Certified Action of the City of Raleigh Planning Commission

Case File / Name: SP-32-10 / New Bern Crossing Hotel

Nature of Case: A five story hotel consisting of 106 lodging units and 1,526 square feet of meeting rooms on a 3.08 acre parcel zoned Neighborhood Business – Conditional Use District.

SP-32-10 / New Bern Crossing Hotel – Preliminary Site Plan

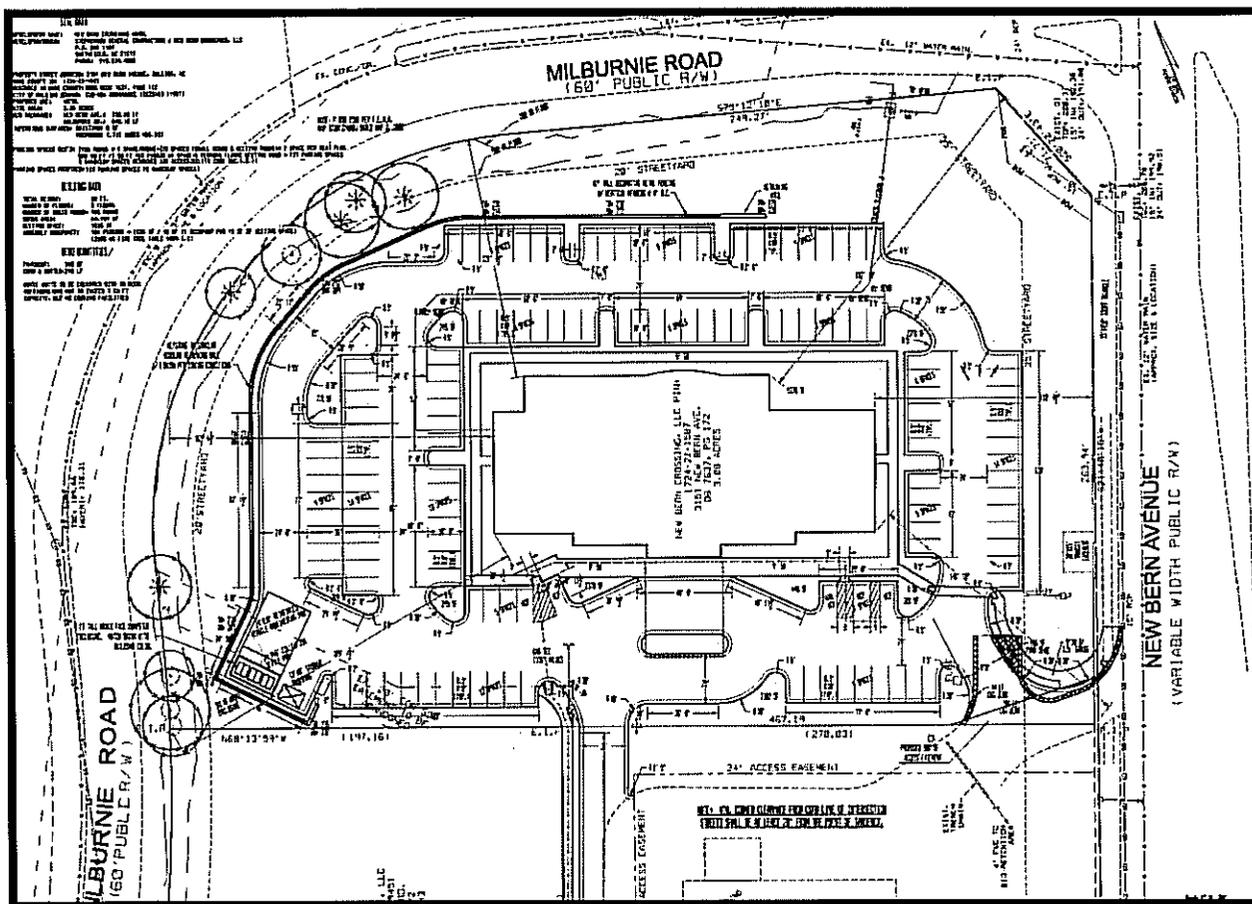
<u>Comment</u>	<u>Response</u>
1. The committee recommends that the building façade facing New Bern Avenue exhibit similar design presence and detail as those facades perpendicular to the street [commensurate with code Sec. 10-2132.2(d)(2)],

- 3 vertical rows of windows along New Bern (in continuation of those on the "front" and "rear" elevations).
 - Providing greater architectural prominence to the entrance door facing the street (e.g., adding a canopy echoing the design of that on the "front" elevation).

- Increasing the degree of wall articulation, to emulate that of the "front" elevation (e.g., bump out central section of the façade sufficiently to create a vertical shadow line on either side of the section).

2. Break up the vertical mass of the proposed retaining wall (20' at highest point) along Milburnie Road [commensurate with code Sec. 10-2132.2(d)(3)], through such measures, singly or in combination, as:

- Terracing the wall, adding plantings at the wall base and on any terrace.
 - Adding ribs and/or recesses to segment the mass vertically.
 - Adding vining plants to cover the wall surface.

- Adding masonry bands of complementary color.
3. Design site lighting such that fixtures are set back from the site perimeter [commensurate with code Sec. 10-2132.2(d)(3)], due to the height of the site above the adjacent grade.

Three rows of windows have been incorporated into the side wall as requested. See sheet A-8.

A canopy has been added to the side entrance door as requested. See sheet A-8.

Bump out not provided. See sheet A-8.

Horizontal ribs have been incorporated to the wall to reduce the vertical impact. Additional landscape plantings have been added at the top of the wall along with vines that will cascade over the top of the wall. At the tallest portion of the wall existing trees have been maintained between the wall and Milburnie Ave. that will serve to hide the wall. See sheets EXB-2, TC-1, and LP-1.

Lighting design incorporates low level lighting and minimal spillover. See sheet C-1.
